# RESPONSE TO SUBMISSIONS REPORT

ALEX AVENUE PUBLIC SCHOOL\_SSD\_9368

JUNE 2019  
P4090  
PREPARED FOR DEPARTMENT OF EDUCATION

Figure 2 - Indicative layout for temporary car park and drop-off zone

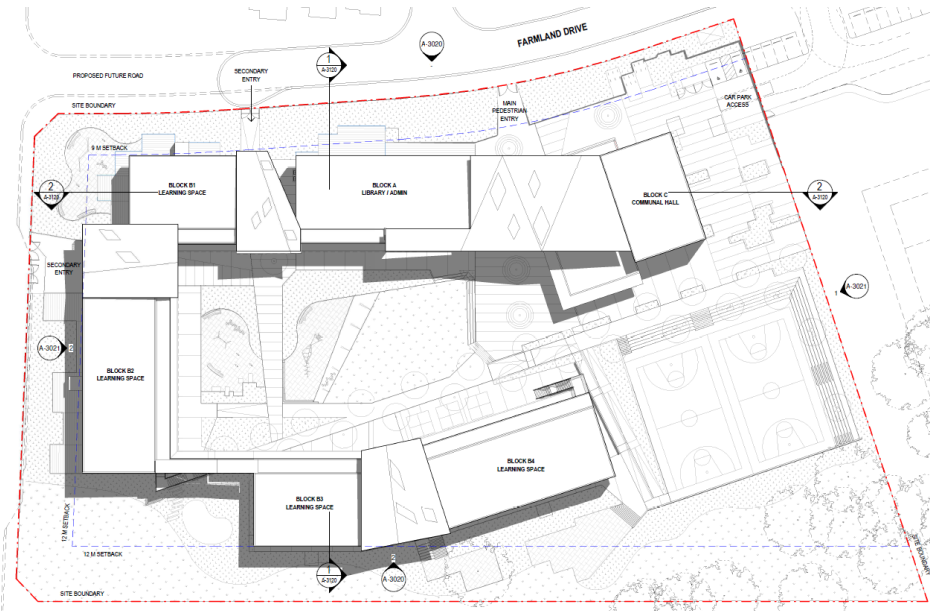
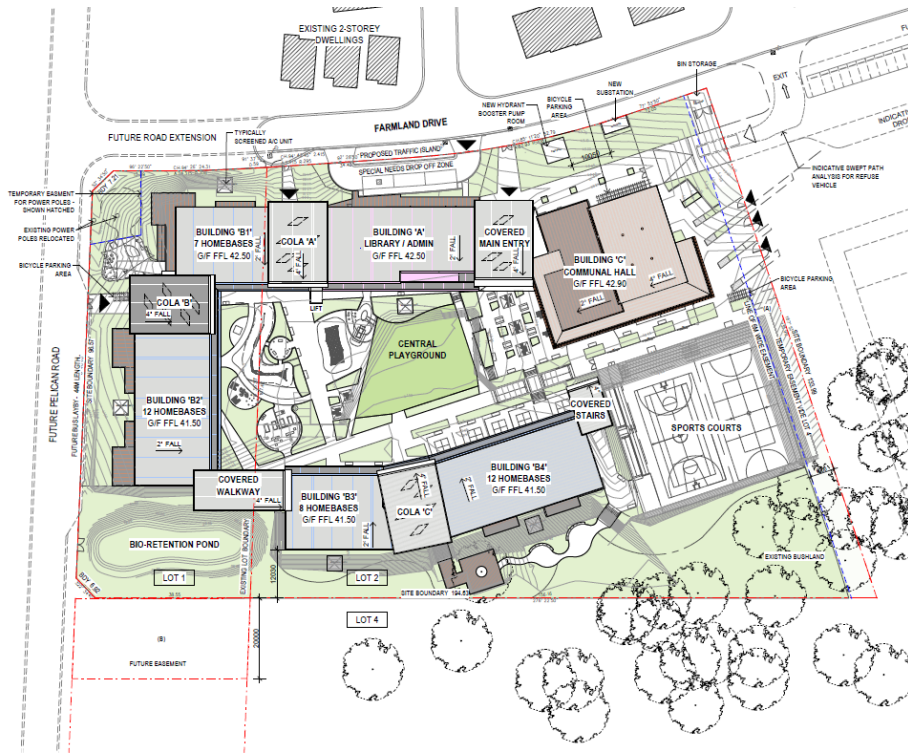
The amended proposal provides an indicative location for temporary onsite staff car parking and drop-off/pick up zone for Stage 1 of the School's operation. During Stage 1, the School is projected to serve a total of 400 students and 35 staff members. The temporary car park will only be needed if Council does not construct the adjacent car park in time for School opening. It will contain 32 staff car park spaces as well as provide a drop-off and pick-up zone capable of accommodating up to five (5) vehicle at any time.

Based on Stage 1 numbers, the temporary car park will require 39 spaces as per the Blacktown Growth Centres Precinct DCP. There is therefore a deficiency of seven (7) parking spaces per the parking requirements outlined in the DCP. This is found to be a necessary outcome due to constraints of the available site and the intention of providing a more flexible and smoother drop-off area. It is further recognised that while the DCP allows each staff member their own space, the mode share of primary school staff in the Blacktown LGA is not comprised entirely of private vehicles, therefore some leeway in parking demand is possible.

Figure 3 – Comparison of Original Site Plan (As Exhibited) and Amended Site Plan

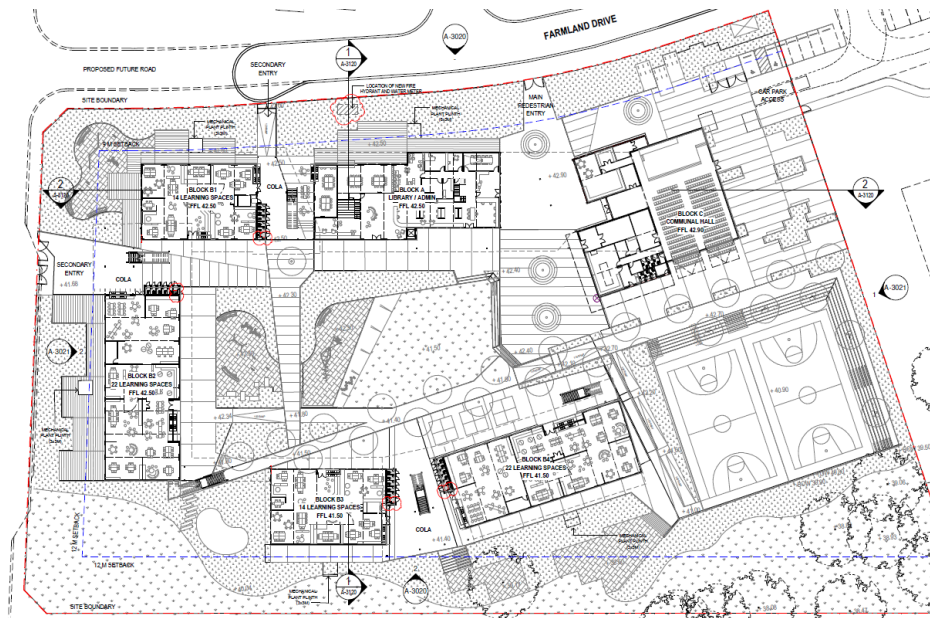
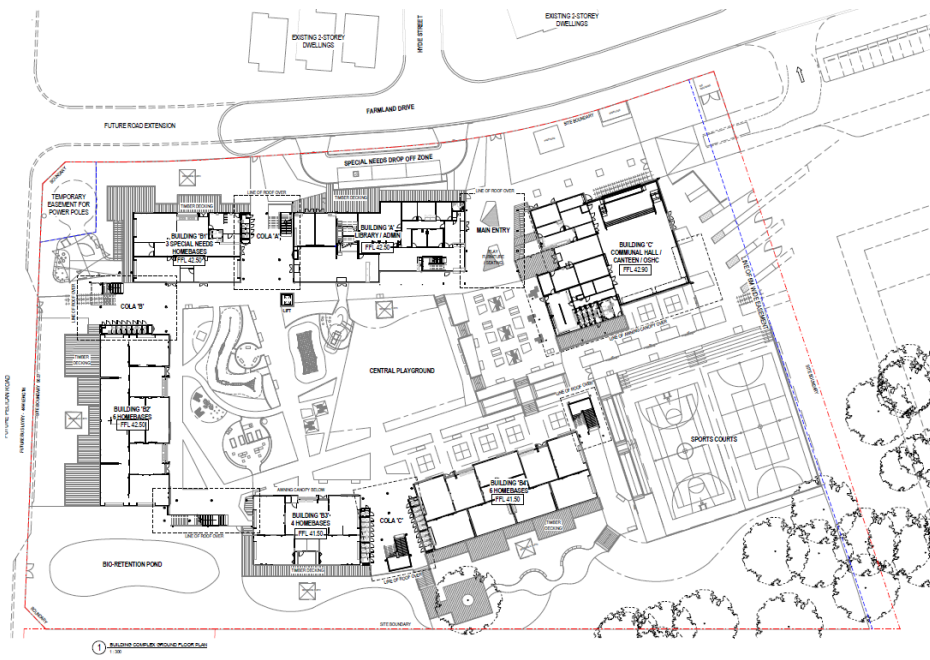
In accordance with Section 55 of the EP&A Regulations, the proposal seeks to make minor amendments to the proposed development. The amendments are a result of design development and in response to agency submissions. The following minor amendments to the original design (as exhibited) are proposed:

- Amendments to building design and internal floor layouts including relocation of external fire stairs and minor changes to the COLAs;
- Relocation of the special needs pick-up and drop-off zone to be contained wholly within the School boundary;

- Provision of a single PWD space within the special needs pick-up and drop-off zone;
- Provision of a temporary 6-metre Easement along the eastern boundary of the site to allow for vehicle access to Lot 4;

- Relocation of all services including the substation, temporary waste bin storage area and PWD parking spaces away from the 6-metre easement;
- Indicative location of a temporary onsite staff car park containing 32 spaces should Council's adjacent car park not be completed in time for the School's opening;

- Amendments to landscaping including additional tree plantings and minor changes to outdoor learning areas;
- Amendments to the civil design following further detailed design;

- Relocation of bicycle storage areas to adjacent to the school hall building; and
- Relocation of hydrant booster pump room within the Farmland Drive frontage.
